# FY 2025-26 Standard Plans Update Training

Rick Jenkins, P.E  
State Standard Plans Engineer  
Roadway Design Office  
[Rick.Jenkins@dot.state.fl.us](mailto:Rick.Jenkins@dot.state.fl.us)

## STANDARD PLANS FY 2025-26 REVISIONS LOG

## Sheet 2: MUTCD Update

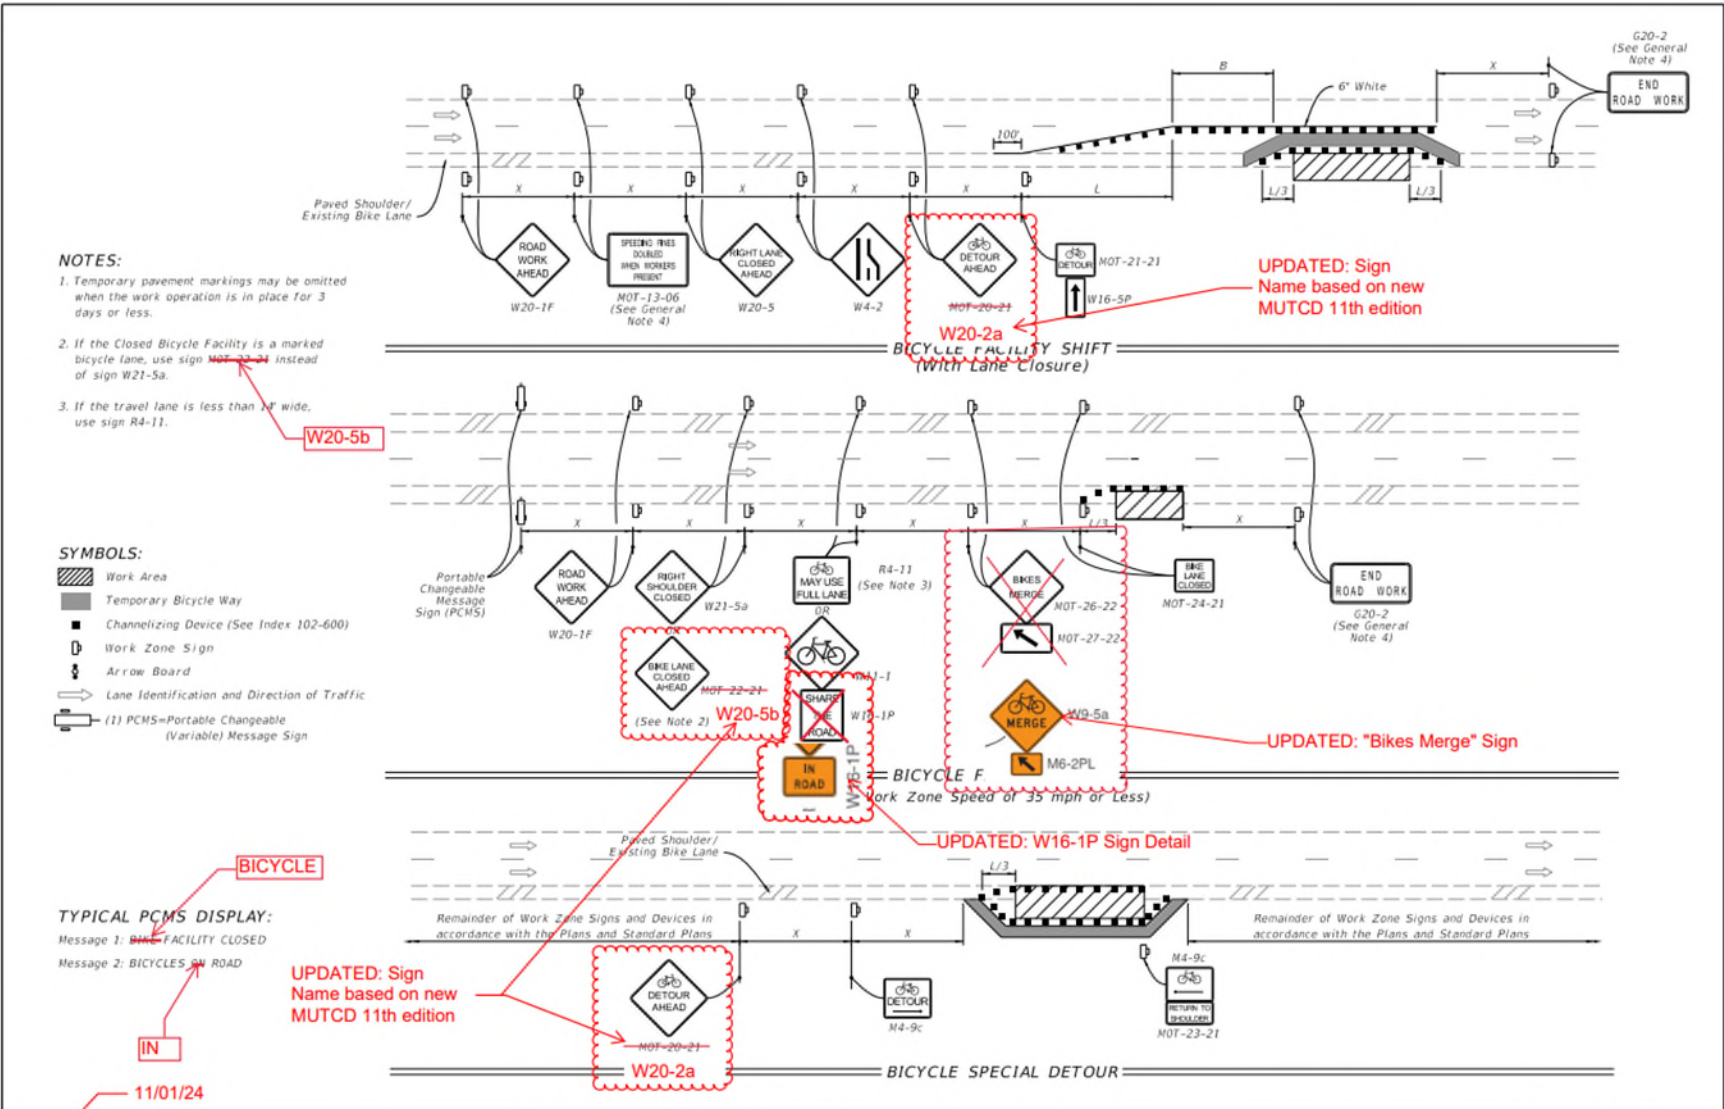
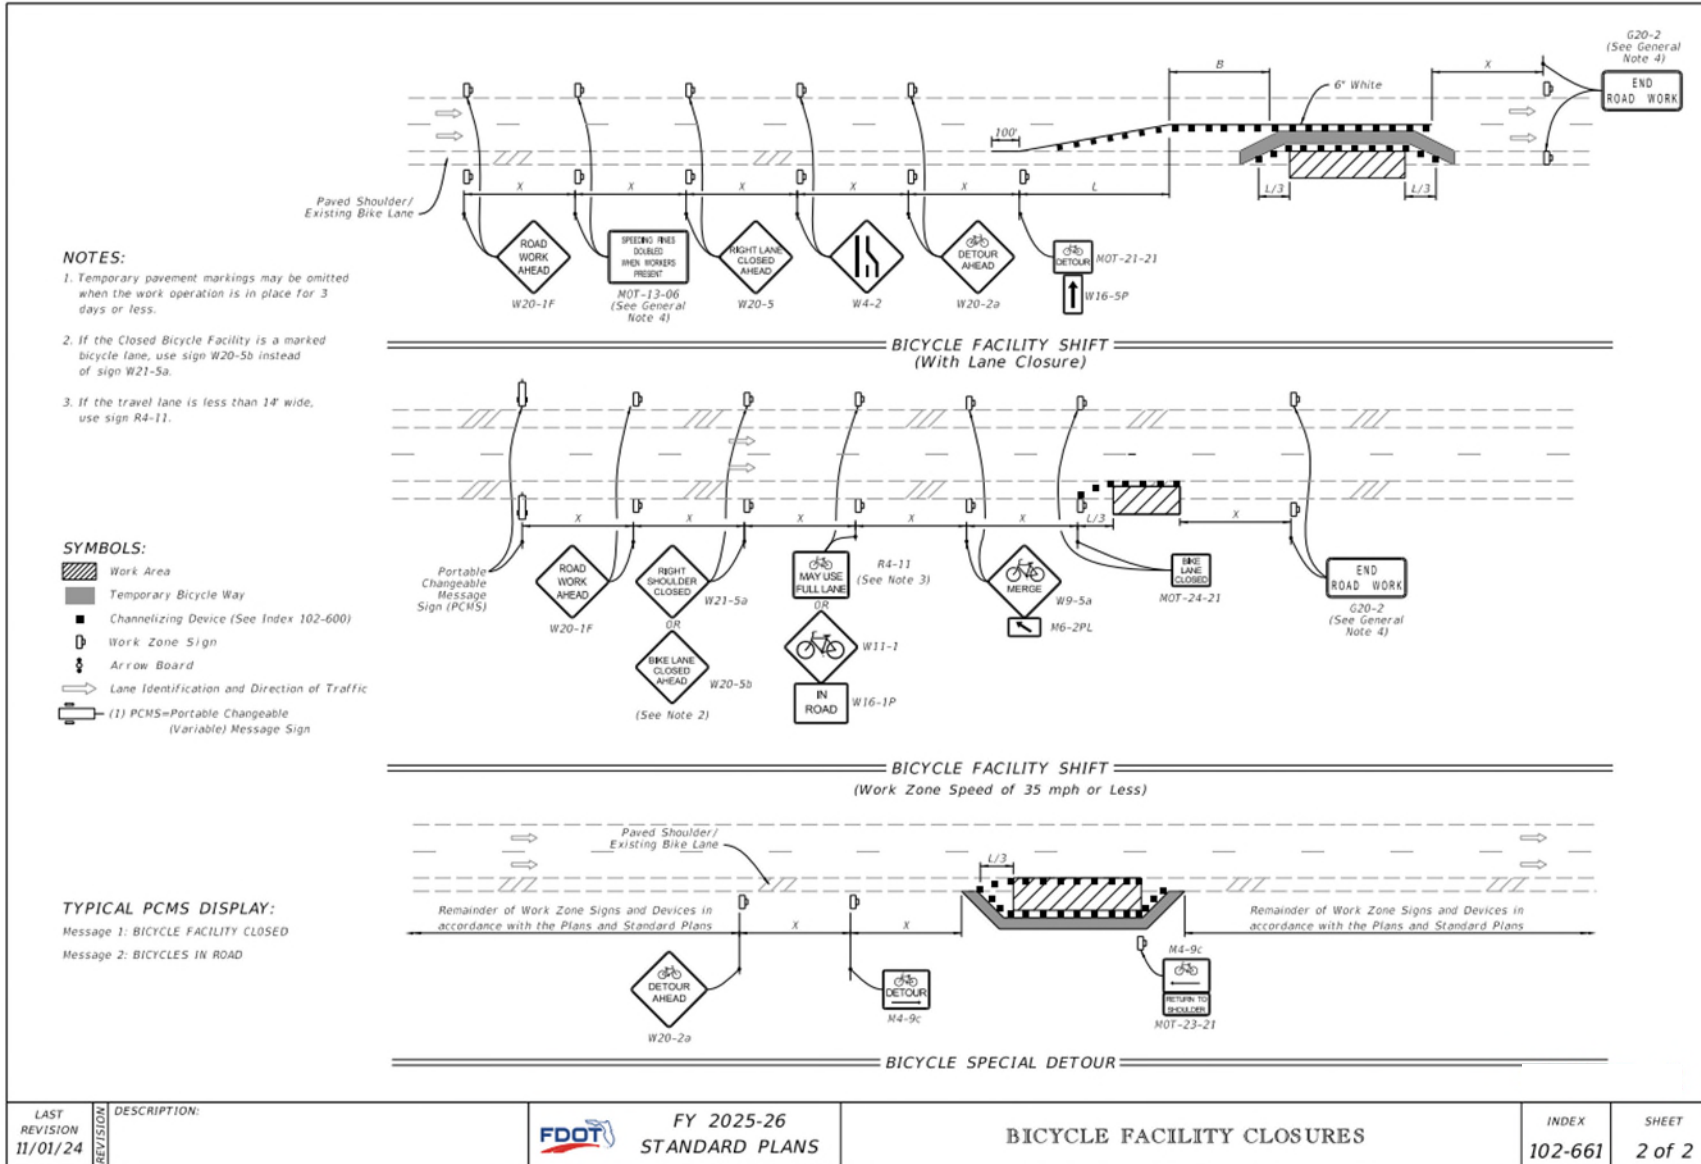
- Updated sign names based on new MUTCD 11th edition. Updated signs W16-1P detail.
- Updated "Bikes Merge" sign. Updated Note 2 to reflect new sign name.
- Updated PCMS messages for consistency.

## Sheet 12: MUTCD Update

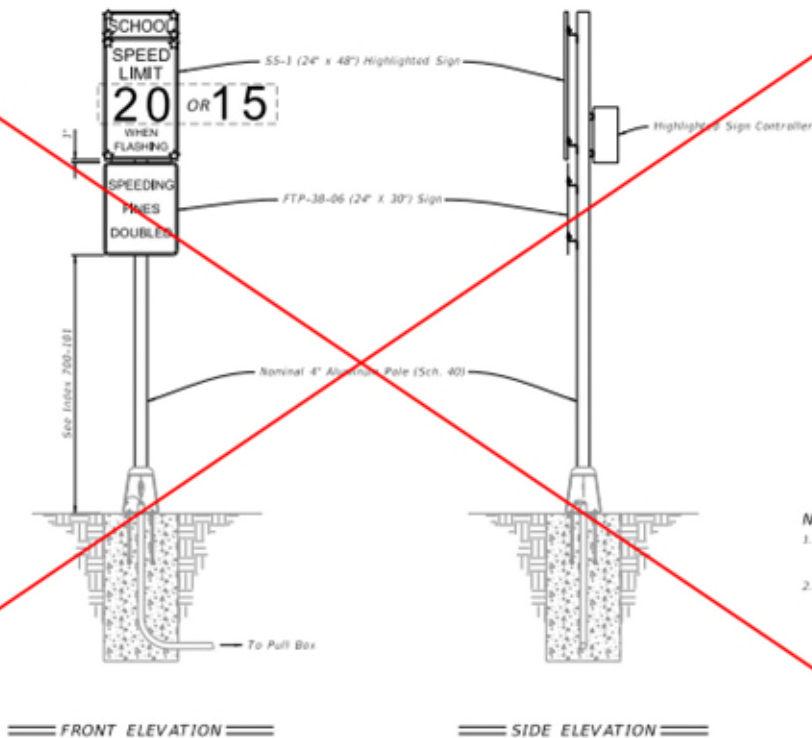
- Deleted MOT-20-21, MOT-22-21, MOT-24-21, MOT-25-21, MOT-26A-22, and MOT-26B-22
- Added MOT-27-25

## Sheet 8: MUTCD Update

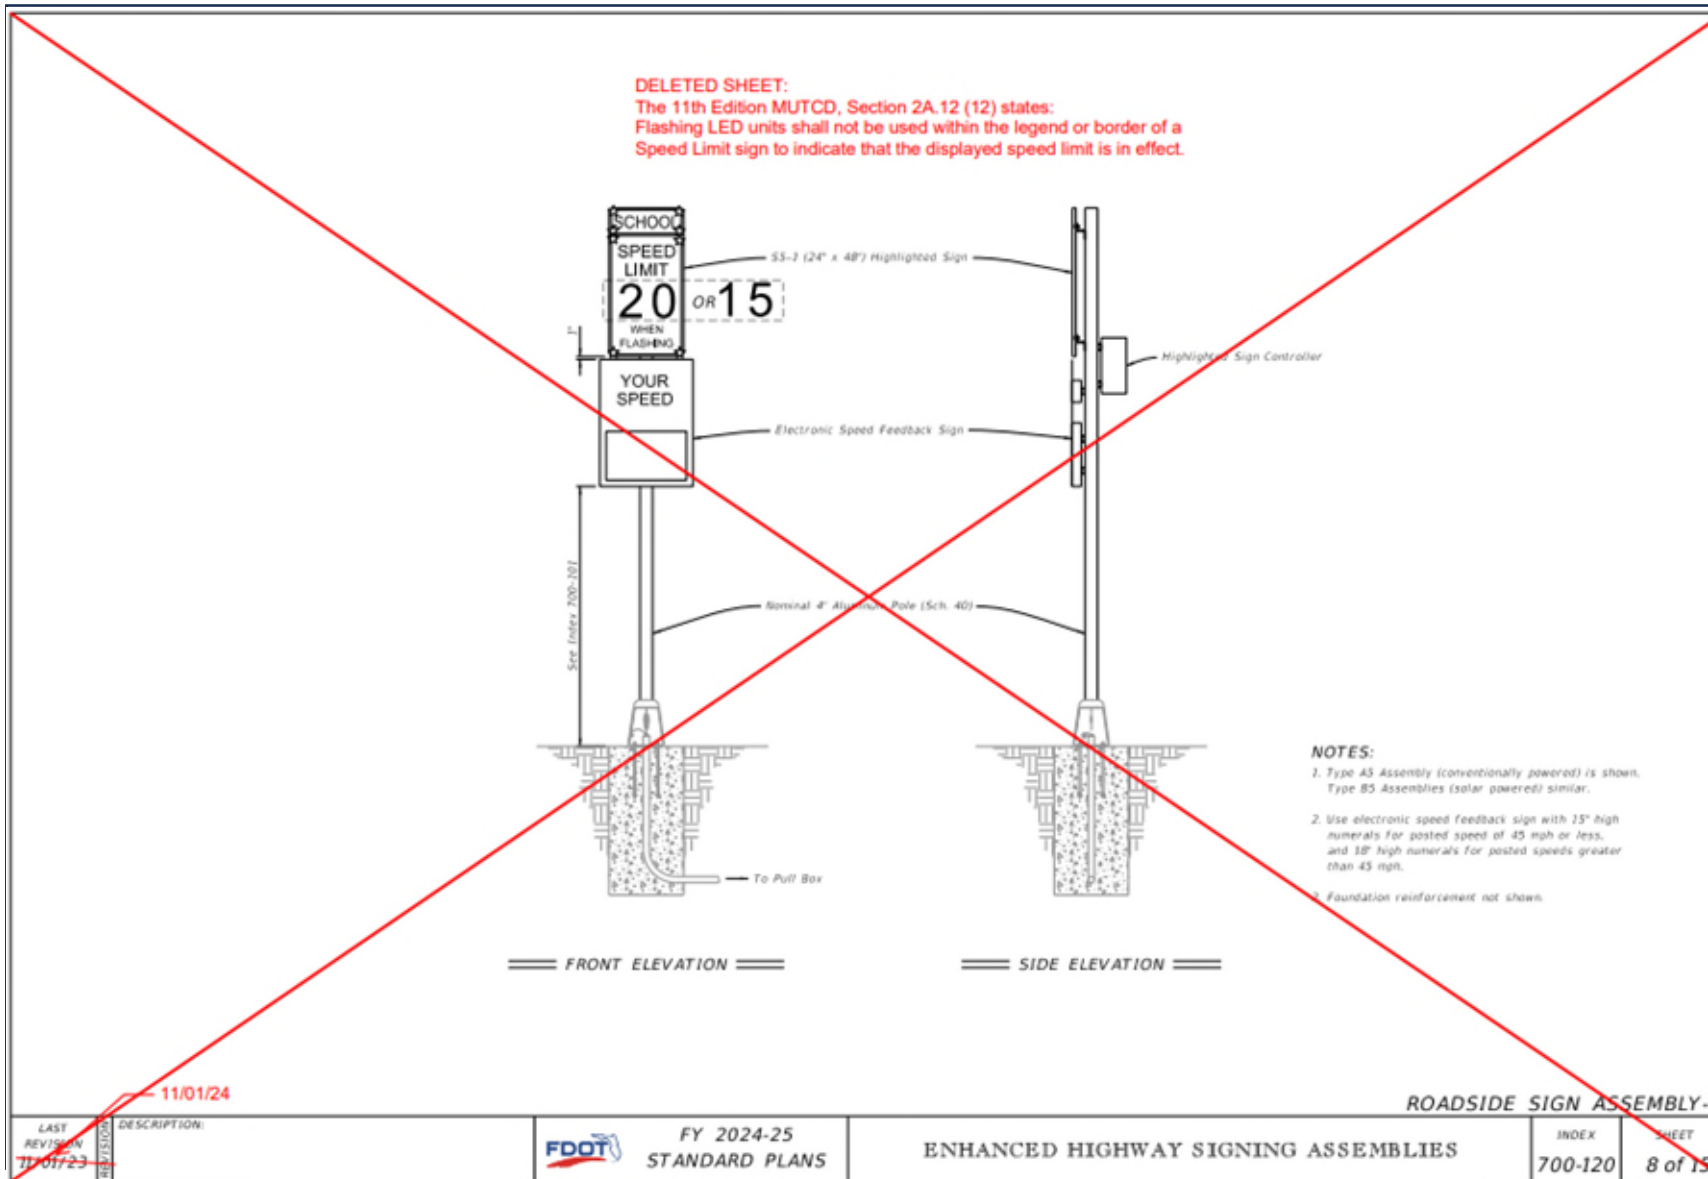
- Deleted Sheet per 11th Edition MUTCD, Section 2A.12.

## Sheet 10: MUTCD Update

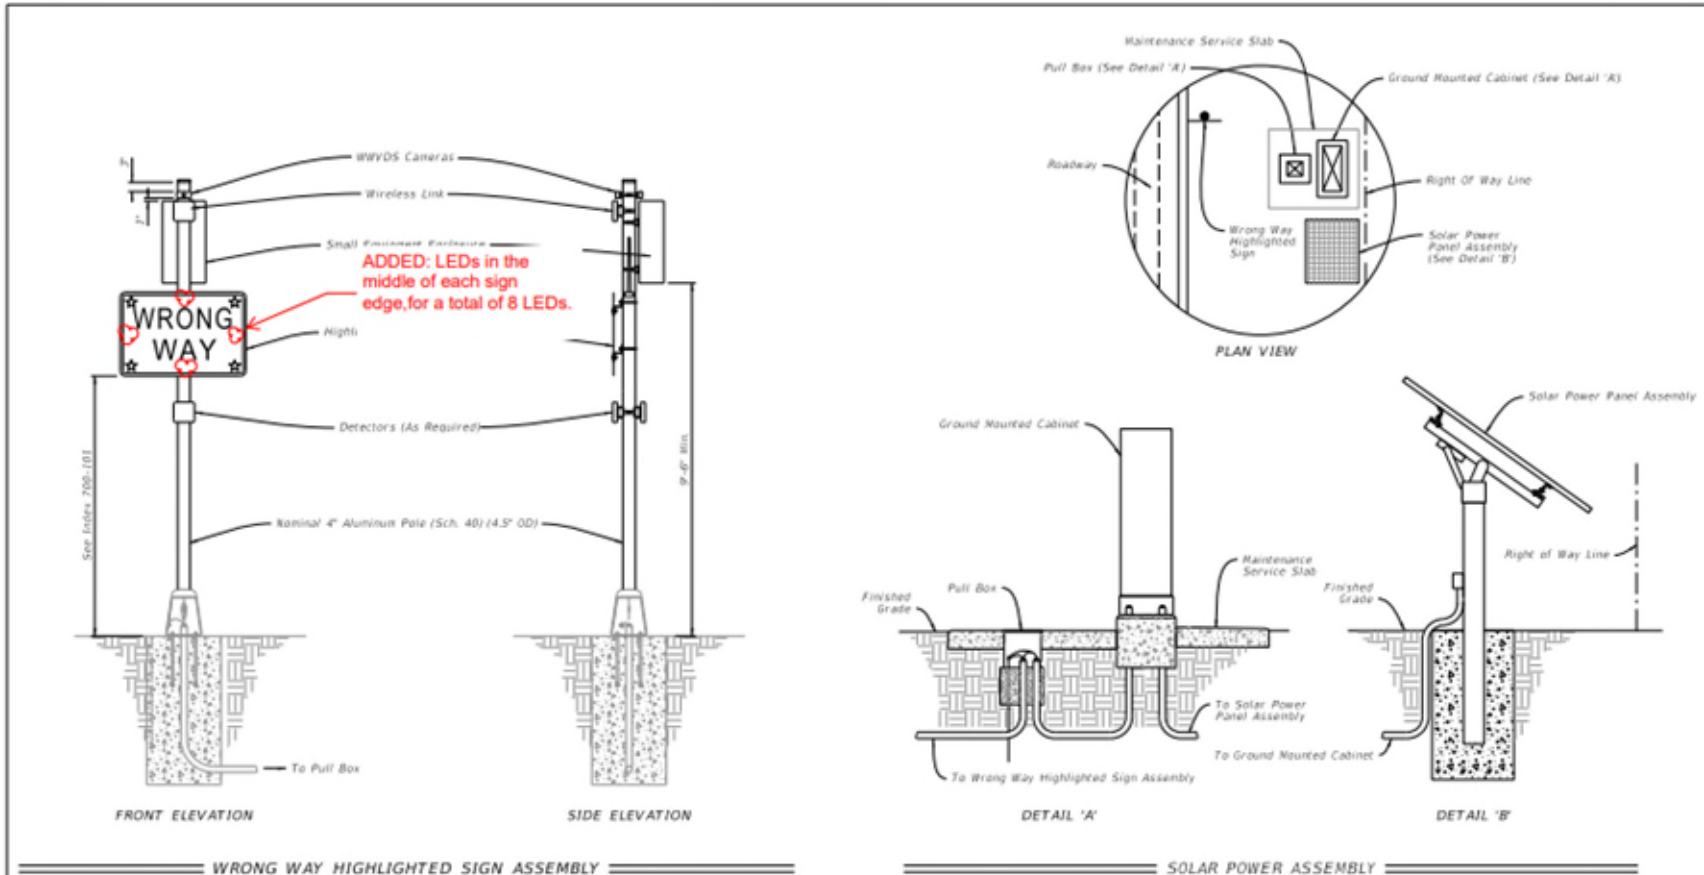
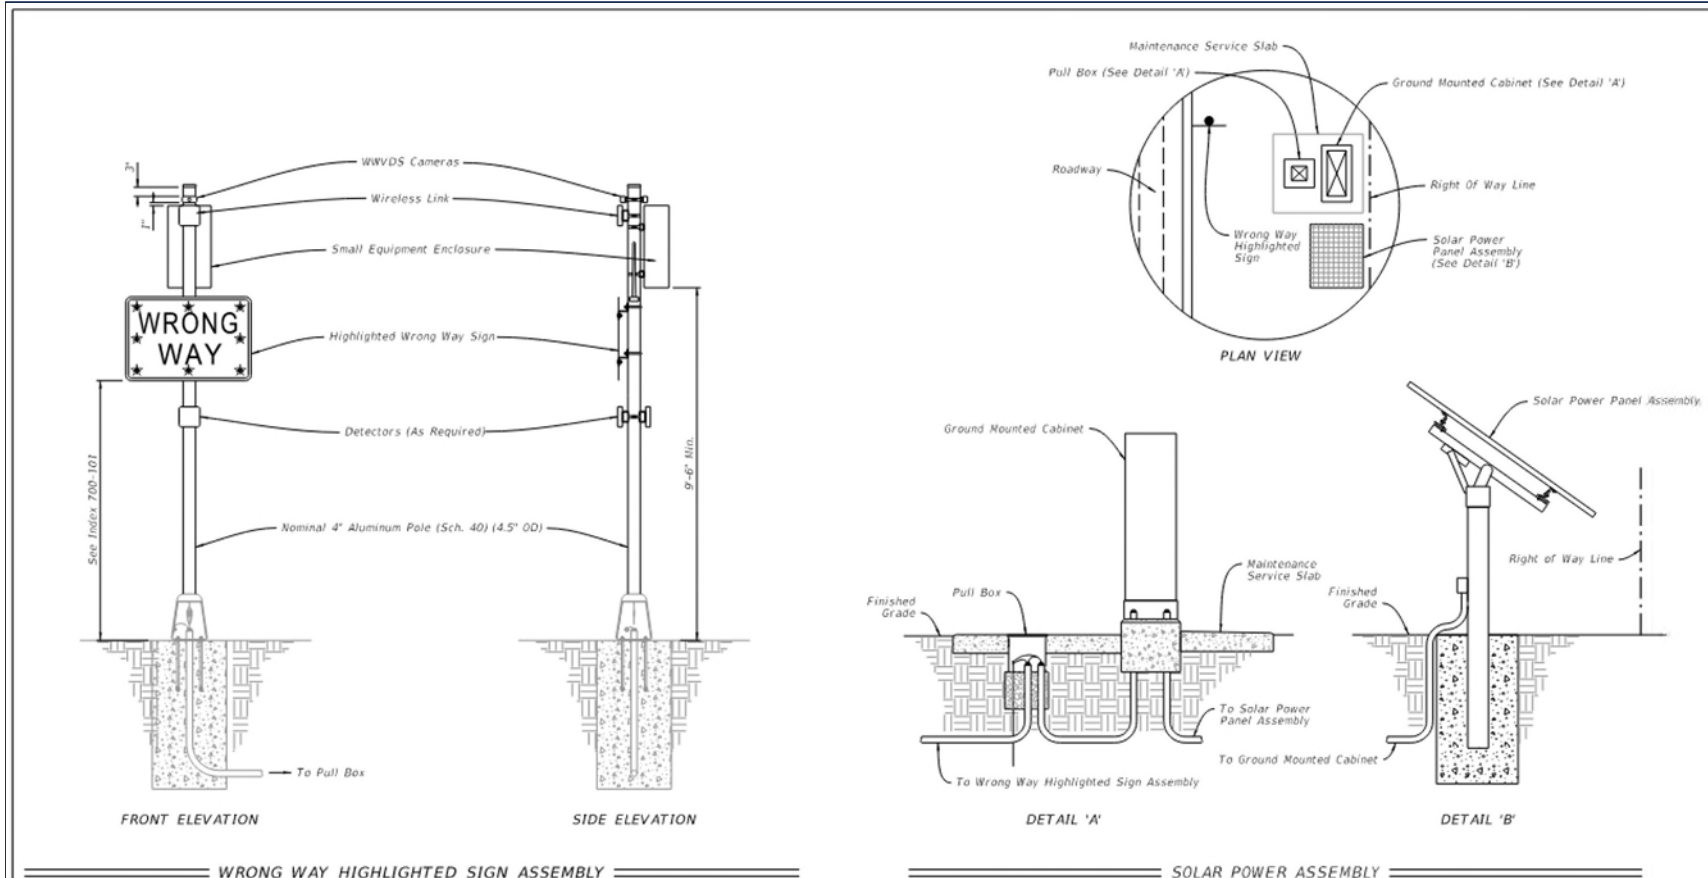
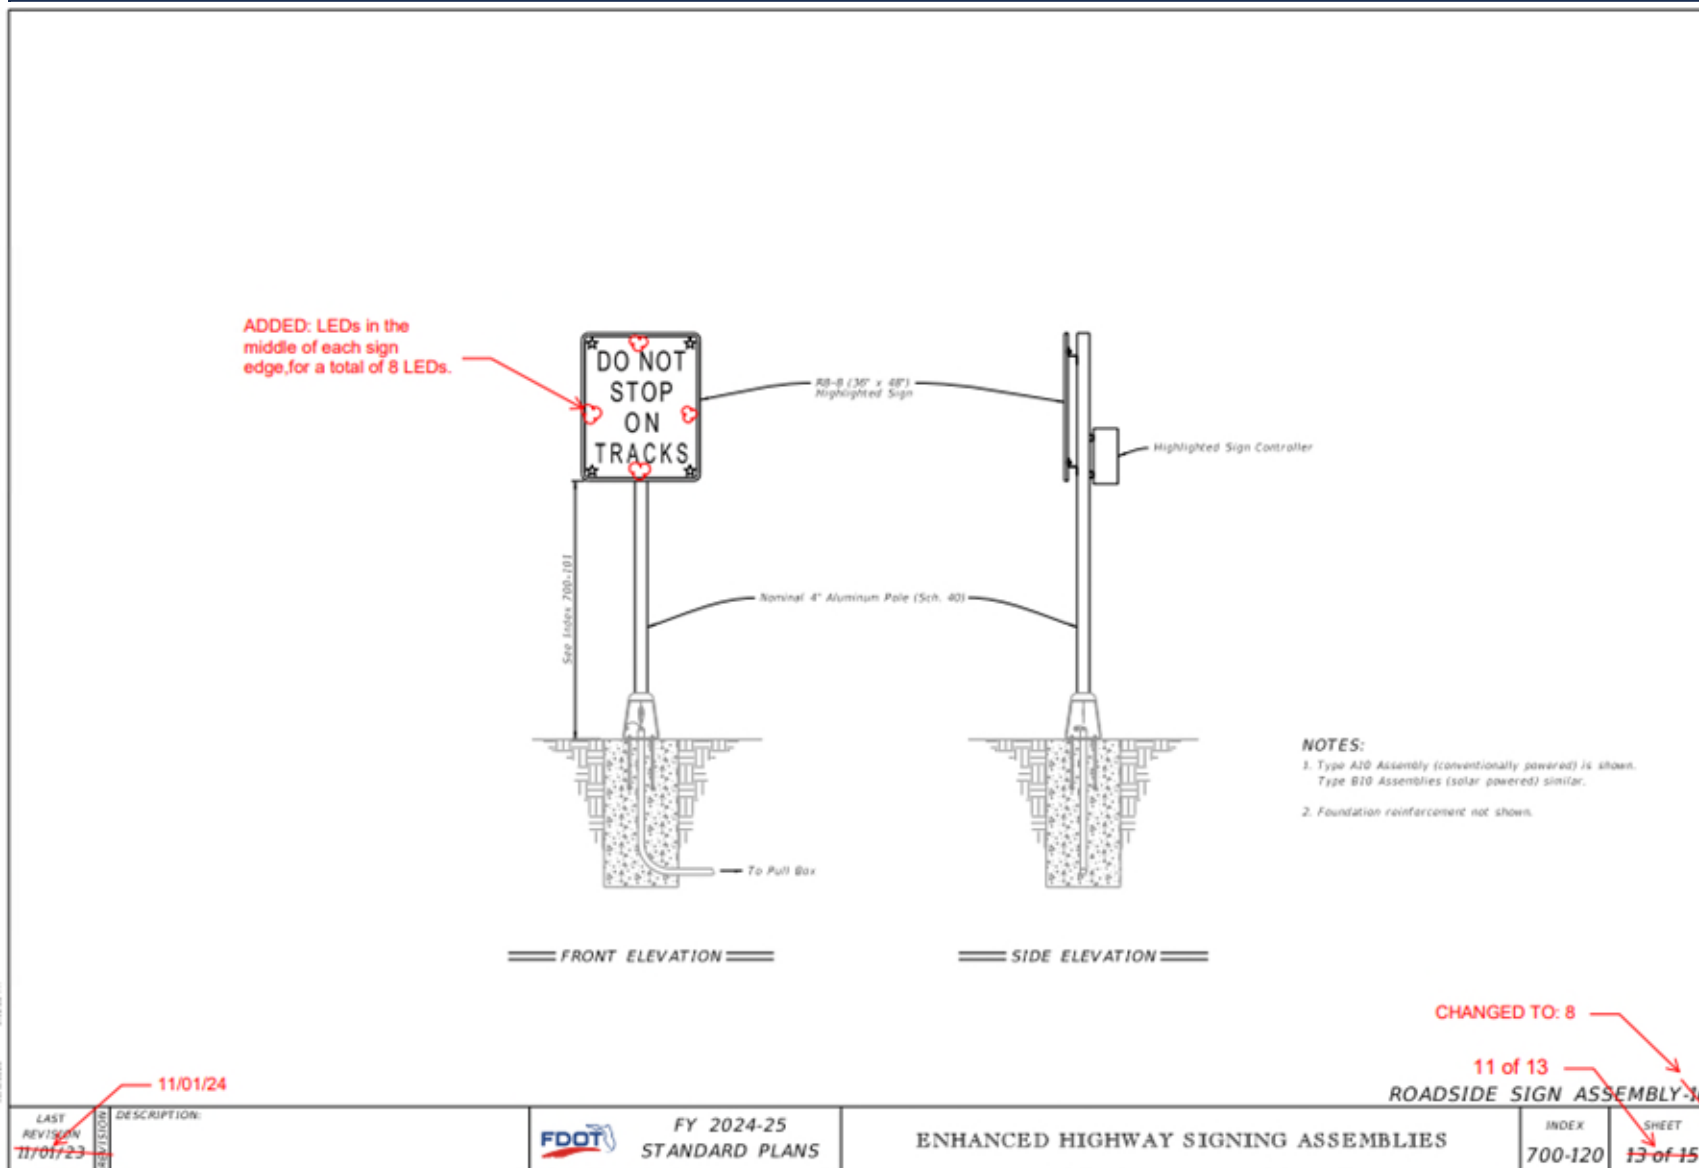
- Added LEDs in the middle of each sign edge, for a total of 8 LEDs.
